HISTORIC AND DESIGN REVIEW COMMISSION

HDRC CASE NO: 2019-632
ADDRESS: 314 LAMAR ST
LEGAL DESCRIPTION: NCB 528 BLK 1 LOT 4
ZONING: R-5, H
CITY COUNCIL DIST.: 2
DISTRICT: Dignowity Hill Historic District
APPLICANT: Timothy Patrick/FDN Home, LLC
OWNER: 10X Properties Investments Series, LLC
TYPE OF WORK: Rehabilitation, construction of a rear addition, and construction of a rear accessory structure
APPLICATION RECEIVED: October 18, 2019
60-DAY REVIEW: December 17, 2019
CASE MANAGER: Edward Hall
REQUEST:

The applicant is requesting a Certificate of Appropriateness for approval to construct a rear, two story addition and enclose an original, covered rear porch.

NEW WORK
FIRST FLOOR PLAN
SCALE: 1/4" = 1'-0"

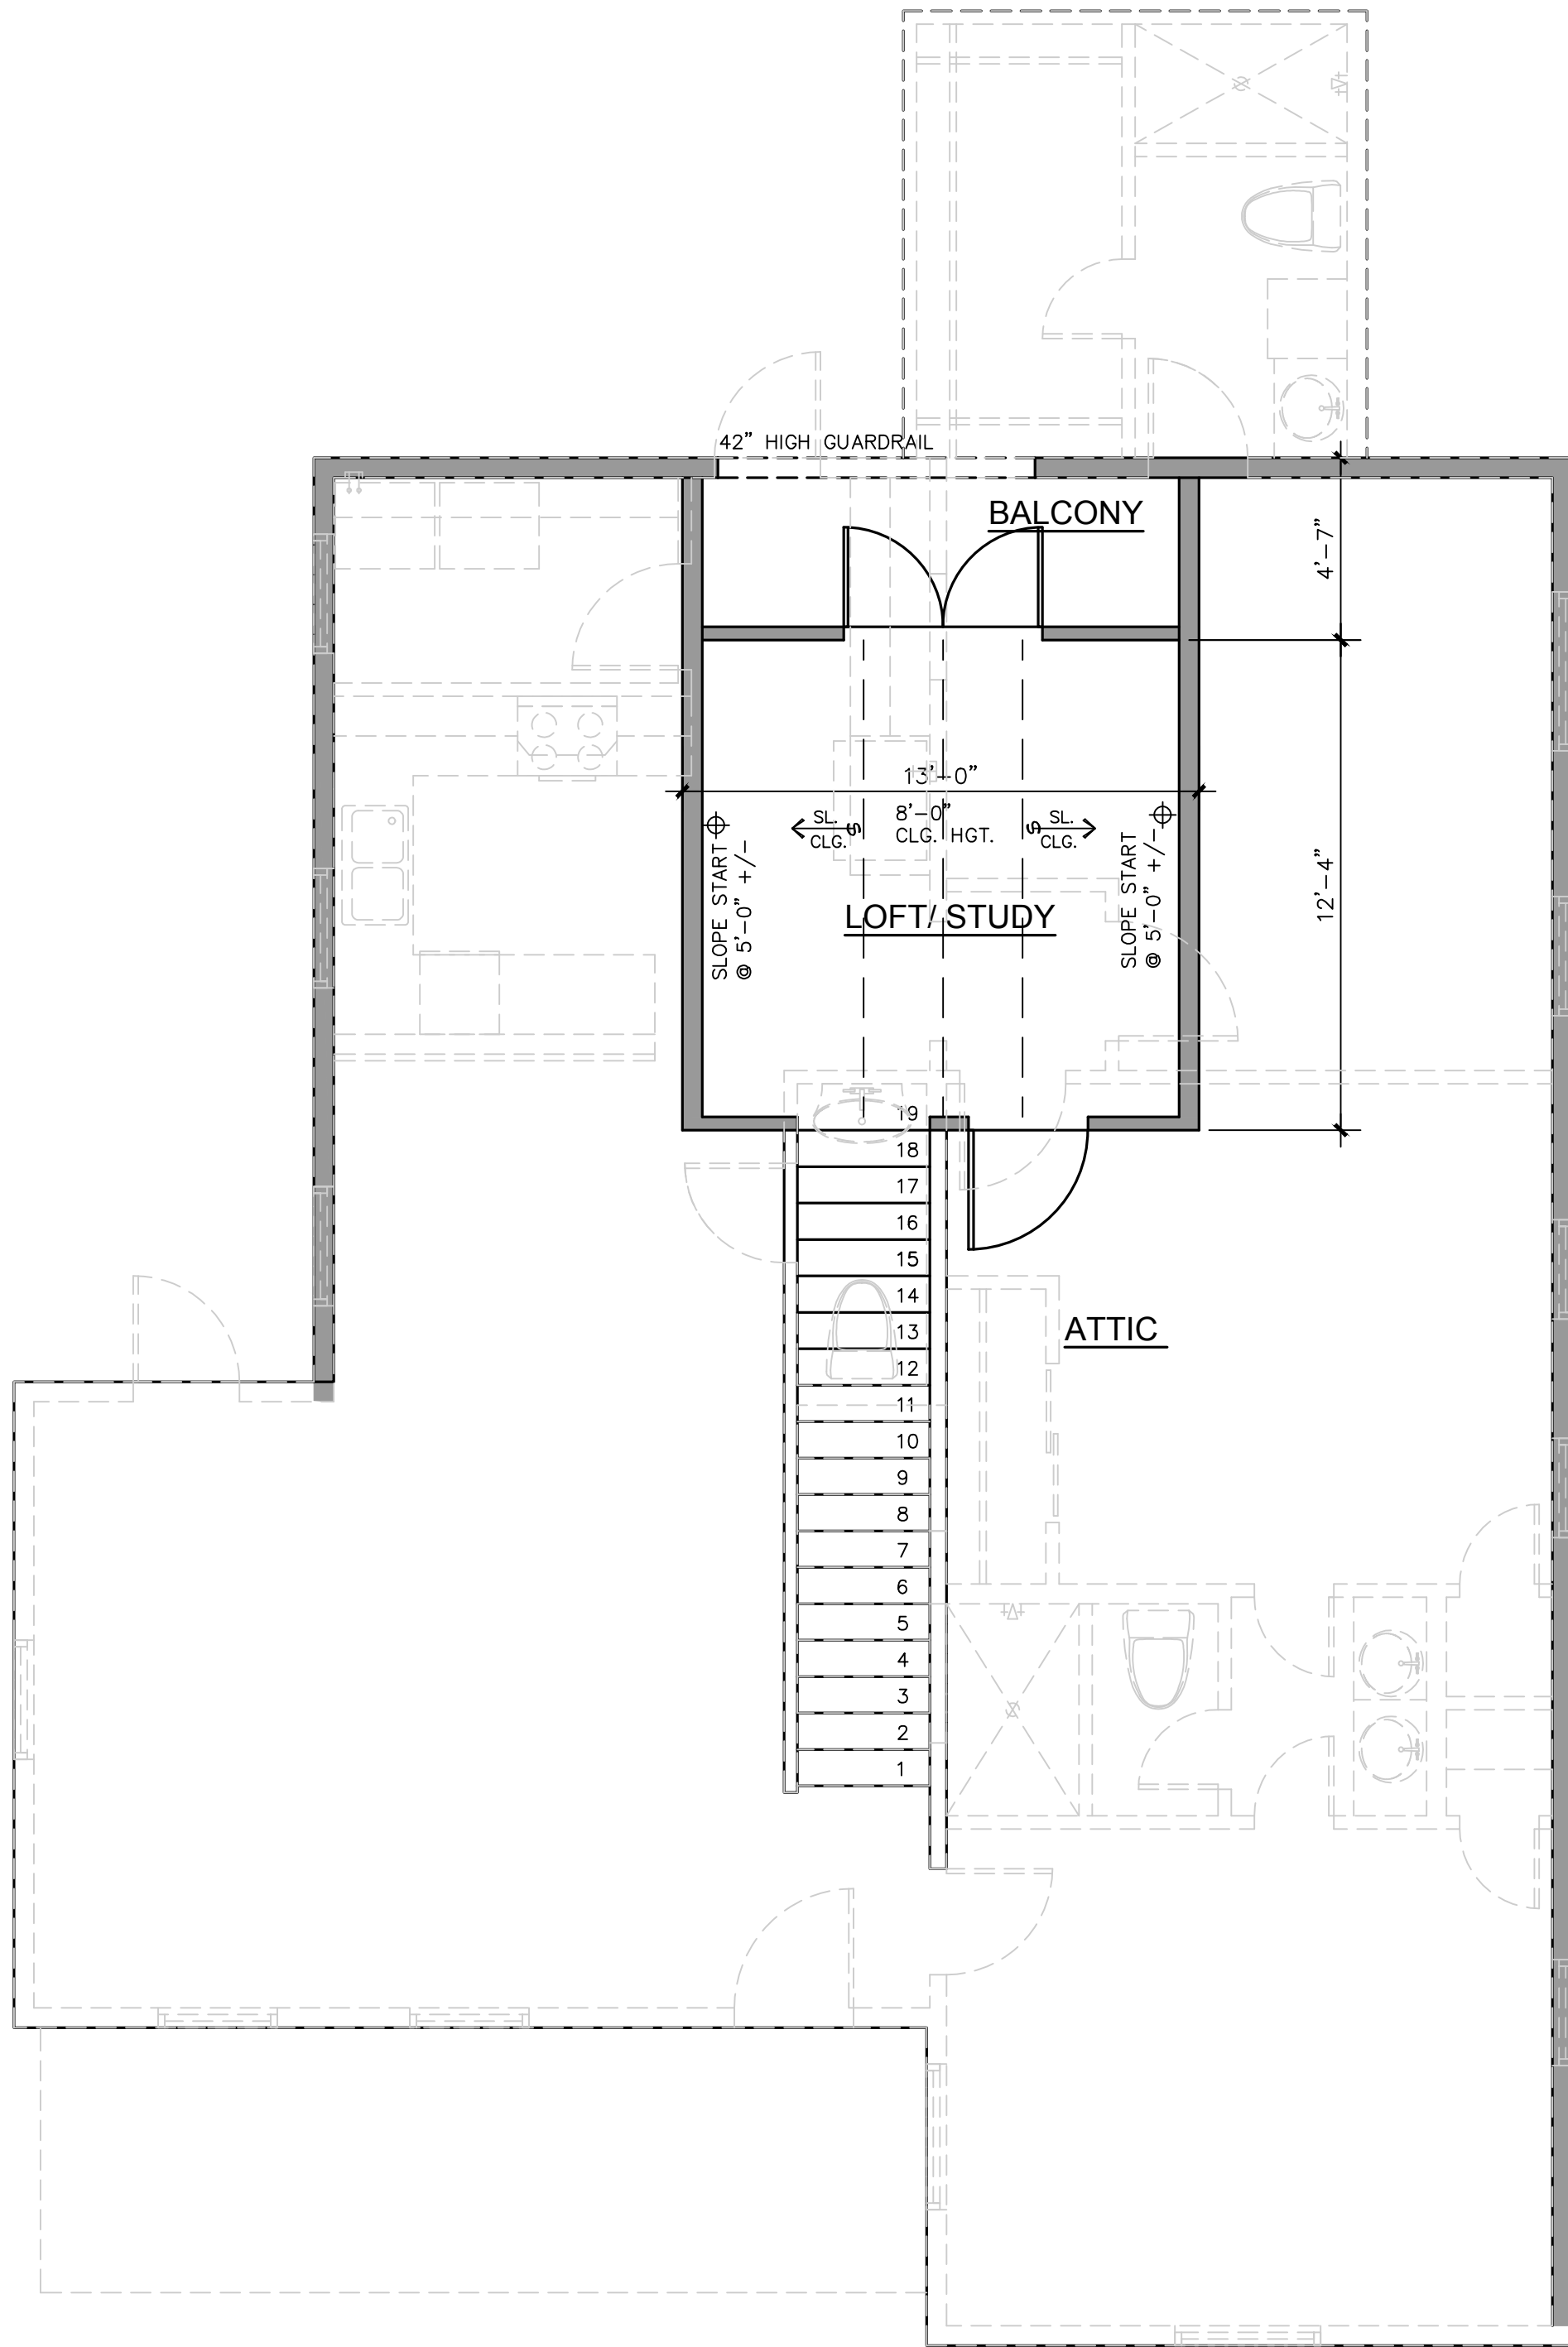
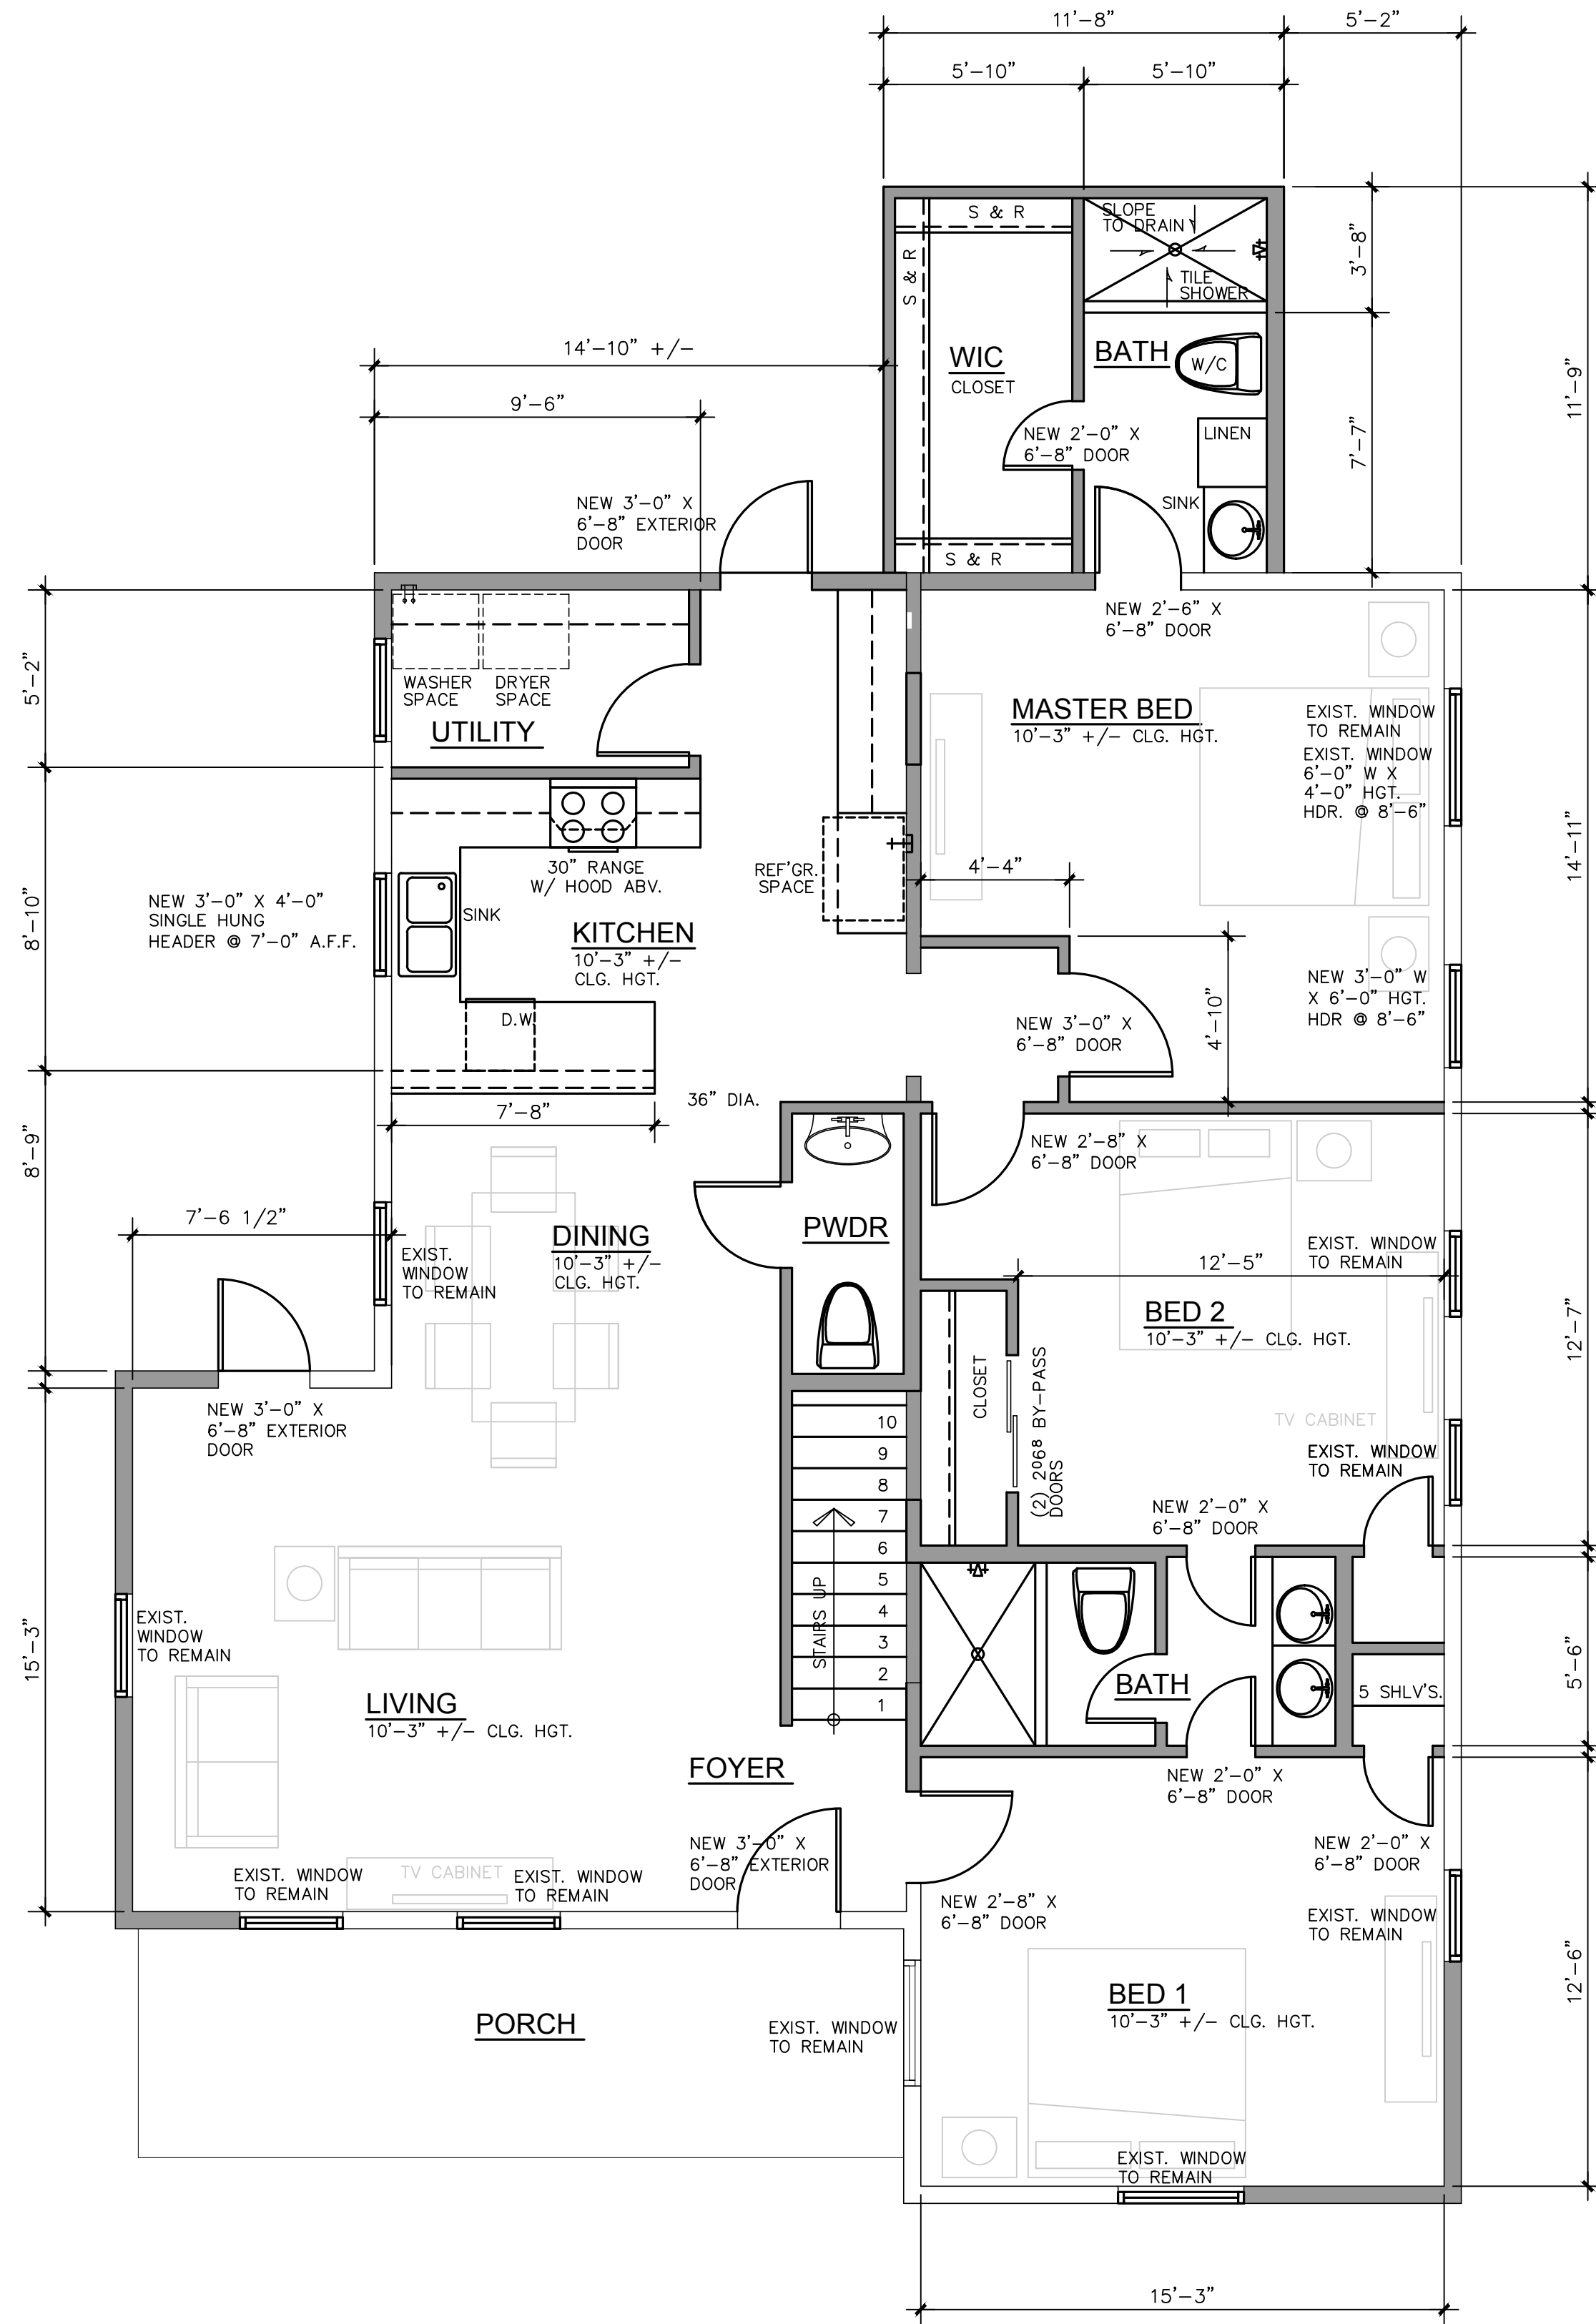
- d. REAR ADDITION – The applicant has proposed to construct a rear addition to feature approximately 300 square feet. The Guidelines for Additions 1.A. states that additions should be sited to minimize visual impact from the public right of way, should be designed to be in keeping with the historic context of the block, should utilize a similar roof form and should feature a transition between the old and the new. Generally, staff finds the size of the proposed rear addition to be appropriate and consistent with the Guidelines regarding footprint, scale and massing.
